STAFF REPORT

Review of City of Glendale Water and Power 2024 Integrated Resource Plan

September 2025 | CEC-200-2025-021

Figure 2: Comparison of GWP's Total Net Energy for Load

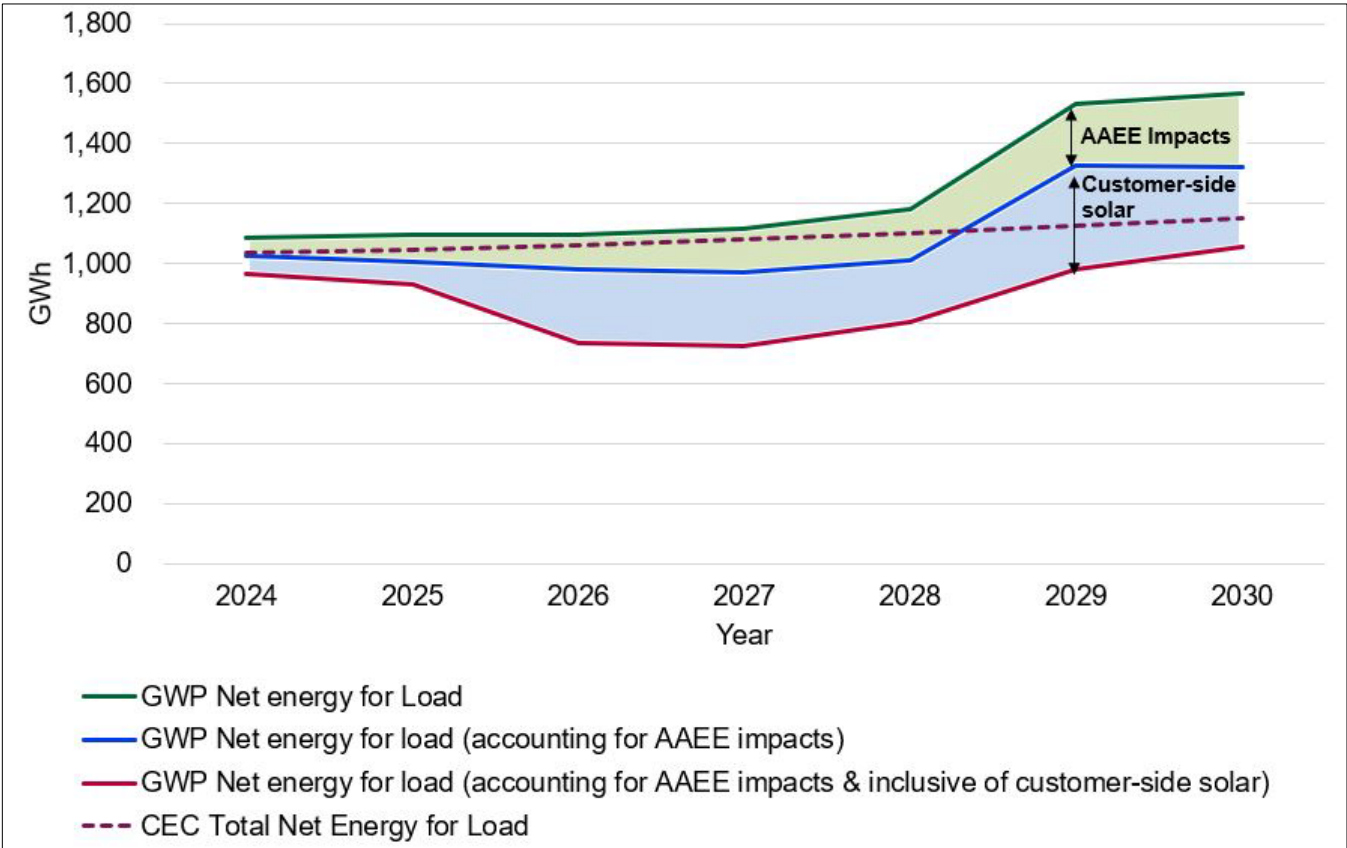
GWP’s forecast of energy requirements is 1,058 GWh in 2030, which is comparable to the CEC’s forecast of 1,153 GWh. However, from 2025 to 2029, GWP’s total net energy for load is significantly lower than the CEC’s forecast after accounting for impacts from energy efficiency and customer-side solar. GWP’s net energy for load follows a similar trend to the CEC’s forecast until 2028, when it sharply increases due to expected load growth from new customers in Glendale’s territory. Figure 2 shows GWP’s net energy for load and the effects of additional achievable EE and customer-side solar. The large load additions that GWP anticipates are offset by these load reductions, resulting in negative load growth through 2027, before energy demand increases.

Figure 4: Comparison of GWP's Peak Demand

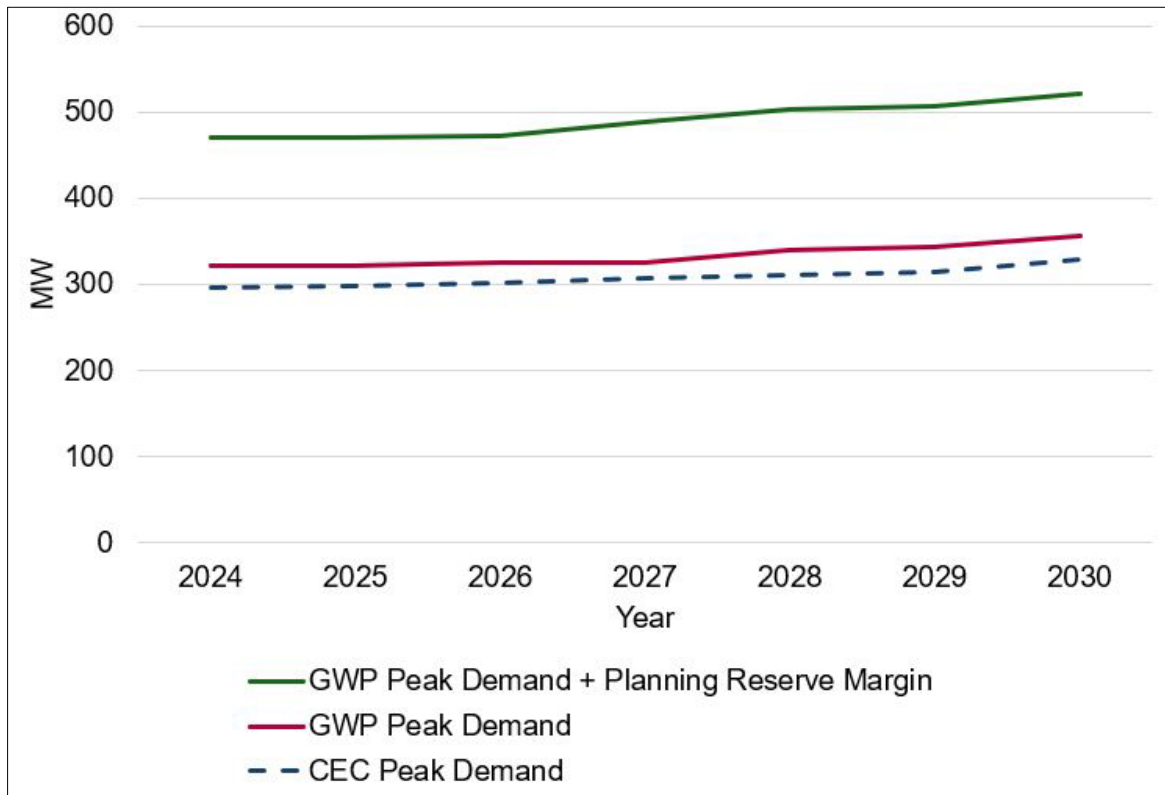
Figure 4 shows GWP's estimated peak demand and planning reserve margin, as well as the CEC's peak demand forecast for GWP.¹⁶ GWP forecasts only a slight increase in peak demand from 2024 through 2030. GWP's forecasted 1-in-2 peak demand projects 356 MW in 2030. The CEC California Energy Demand 2023–2040 Forecast — Planning Forecast 1-in-2 Net Electricity Peak Demand projects a 328 MW peak demand for GWP, which is roughly 7.9 percent lower than GWP's forecast. From 2024 to 2030, GWP's peak demand follows a trend comparable to the CEC forecasted peak demand. The planning reserve margin (PRM) adds an additional 148
